LOS ANGELES RIVER MASTER PLAN
 Negative Declaration/Environmental Assessment

FIGURE 5.12-5
METROPOLITAN WATER DISTRICT OF SOUTHERN CALIFORNIA FACILITY

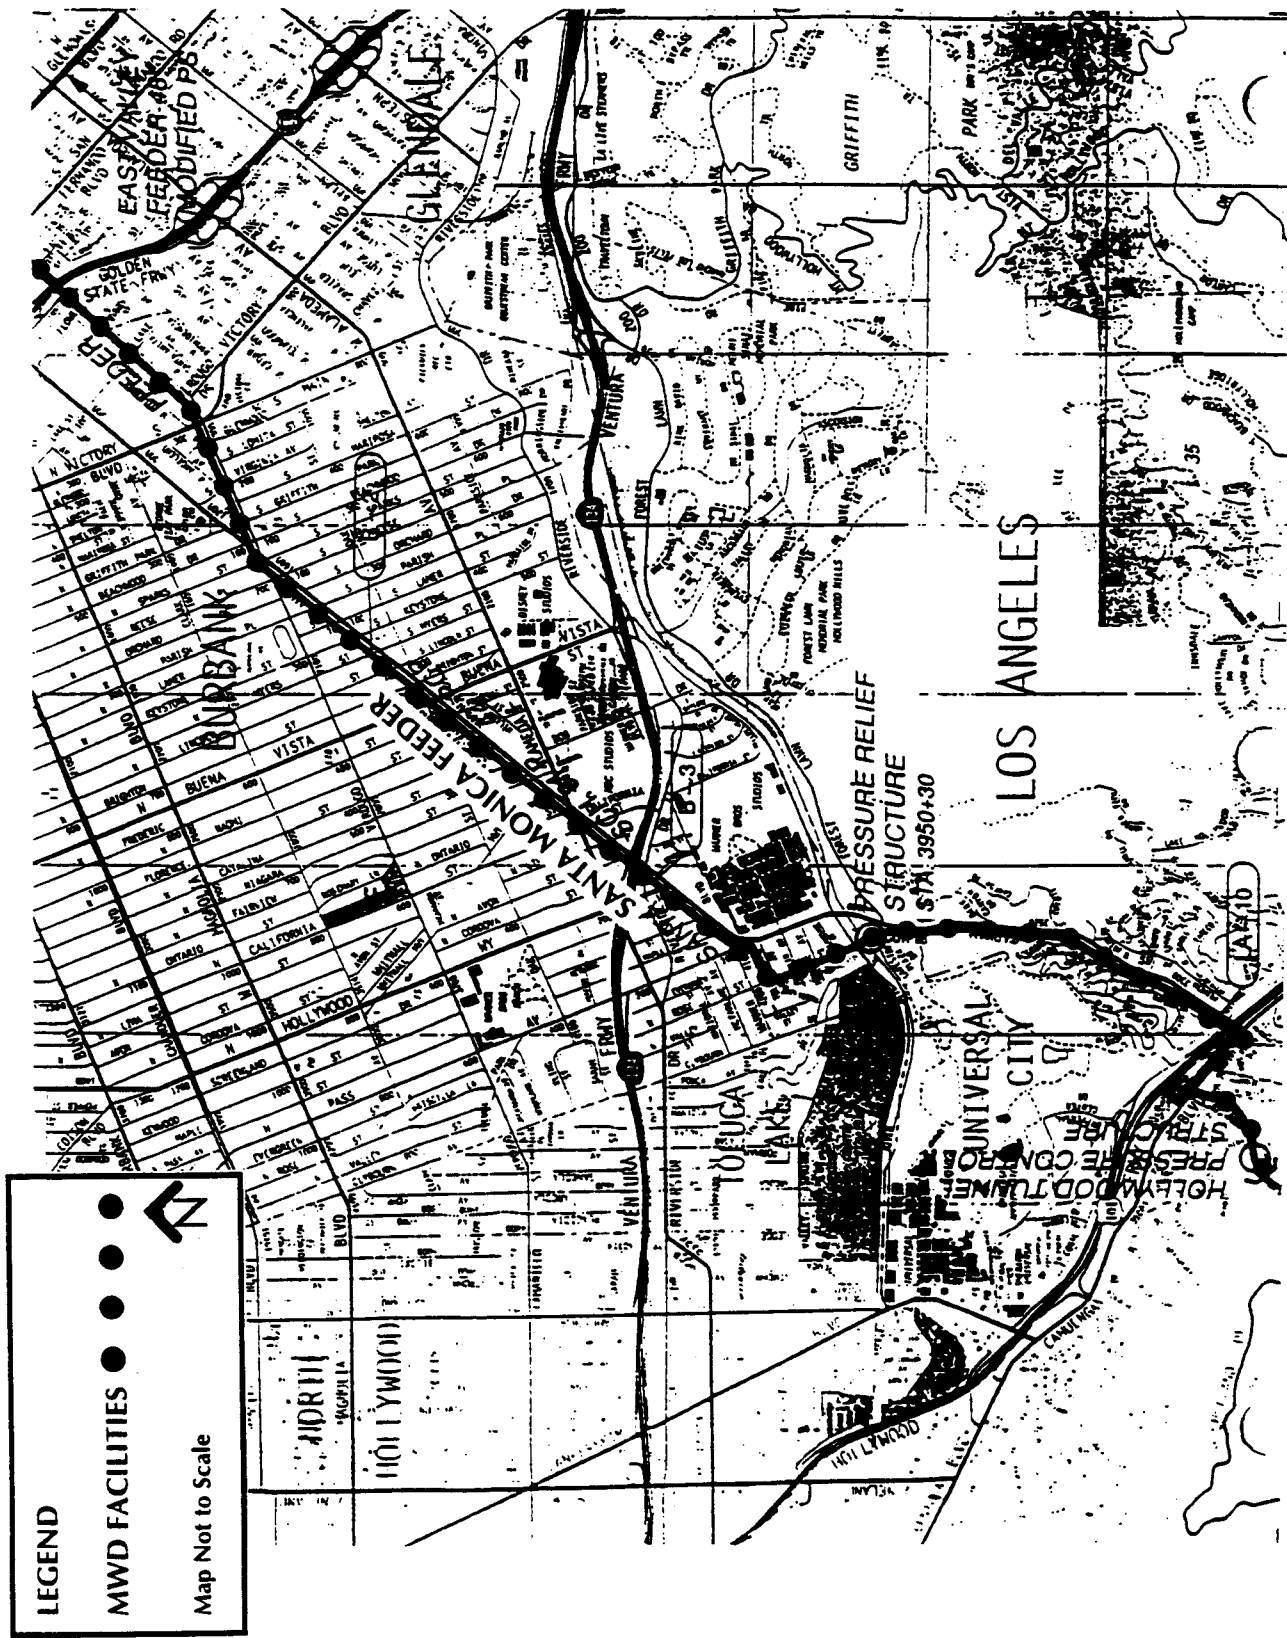
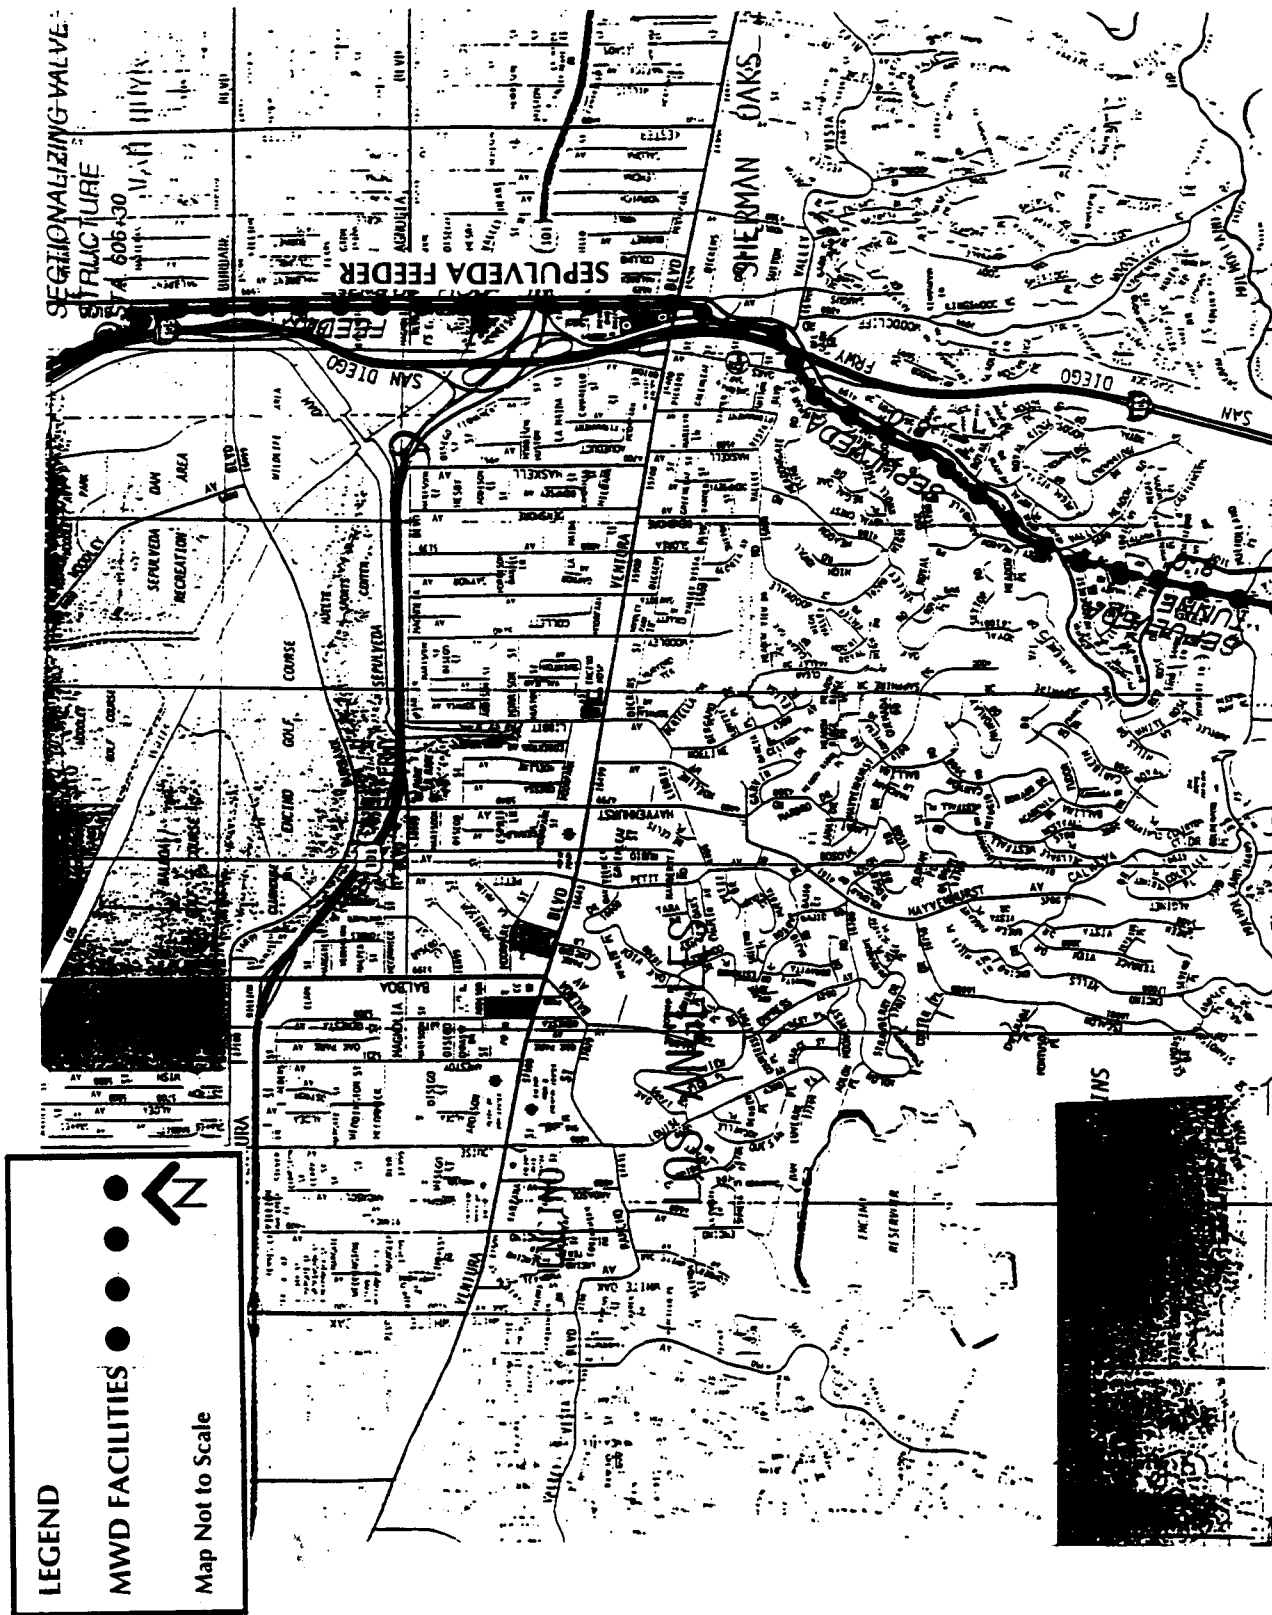
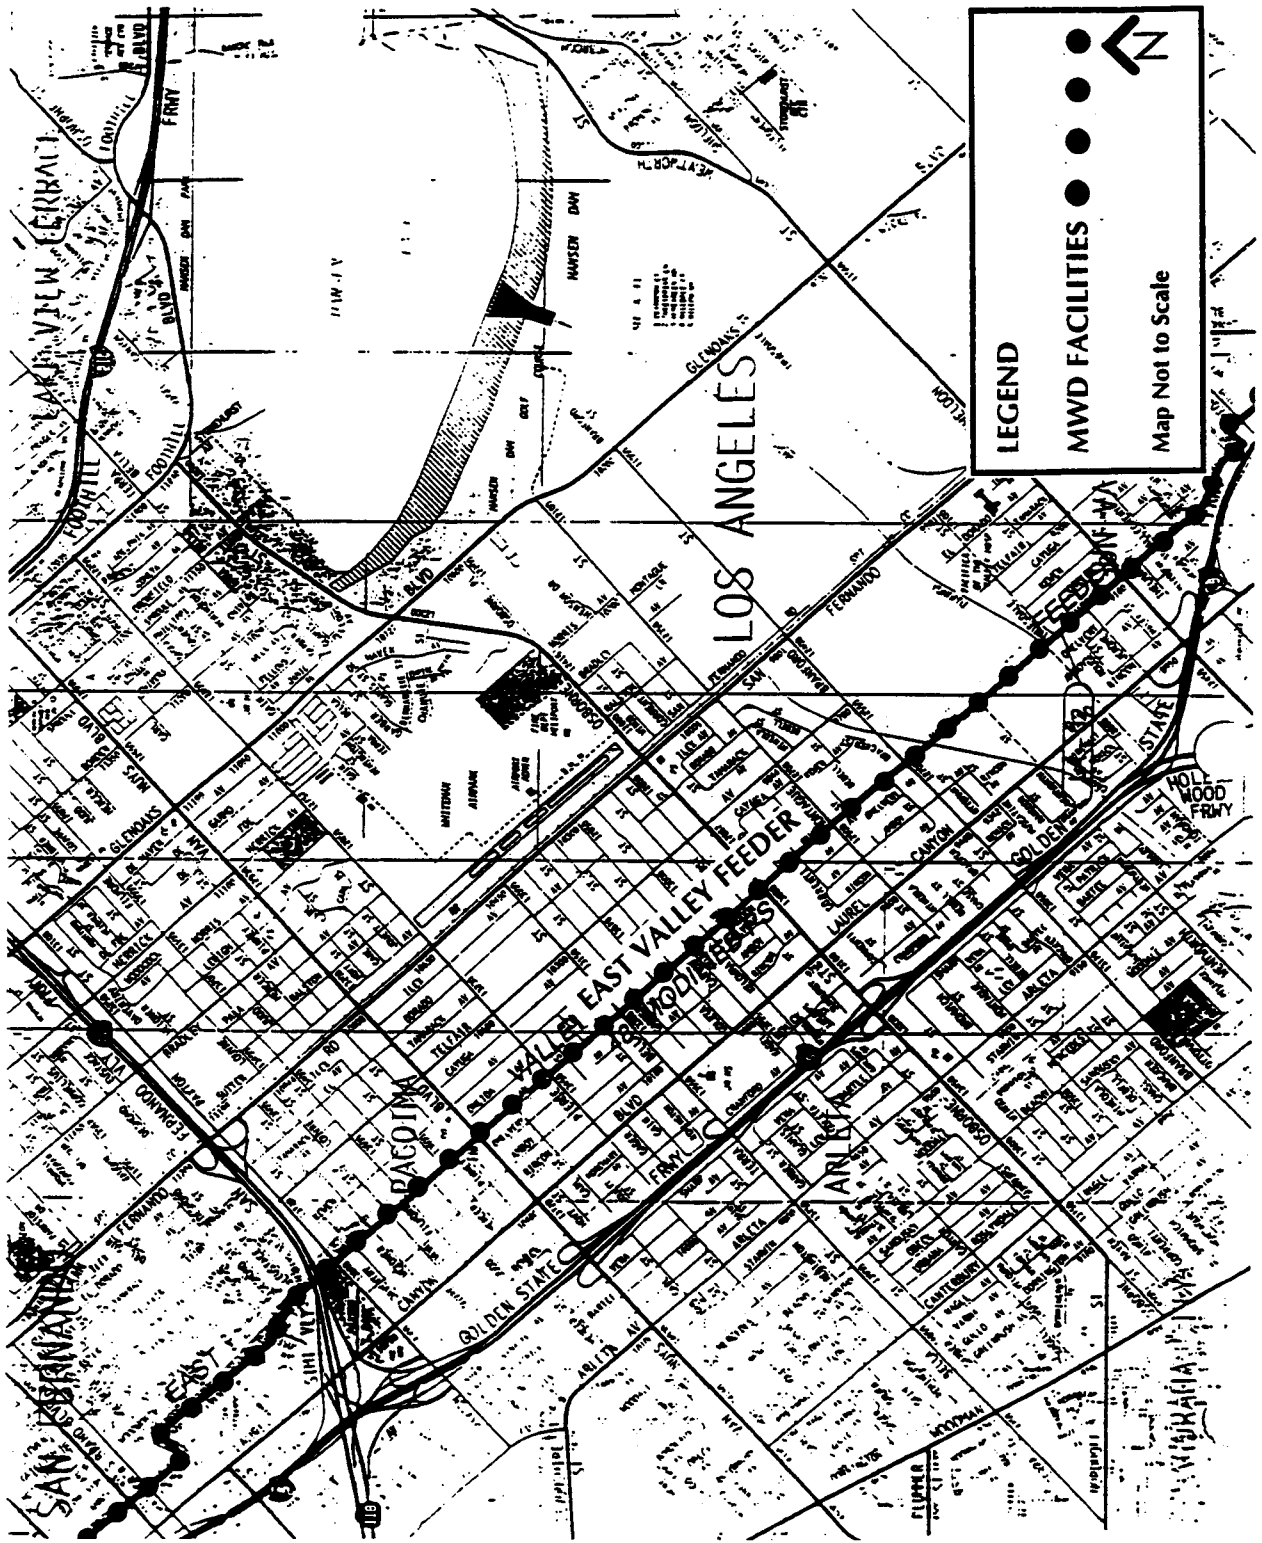
- Section 5.12.2, (Page 5-76a) Add as second paragraph under "Existing Conditions" Section, "In particular, the Metropolitan Water District of Southern California (Metropolitan) has nine facilities in the area of the proposed project. Metropolitan's Long Beach Lateral, Second Lower Feeder, Middle Feeder, West Coast Feeder, Middle Cross Feeder, Palos Verdes Feeder,

Santa Monica Feeder, Sepulveda Feeder, and East Valley Feeder cross or are adjacent to the proposed improvement areas.”

See addition of Figures 5.12-1, 5.12-2, 5.12-3, 5.12-4, 5.12-5, 5.12-6, and 5.12-7.
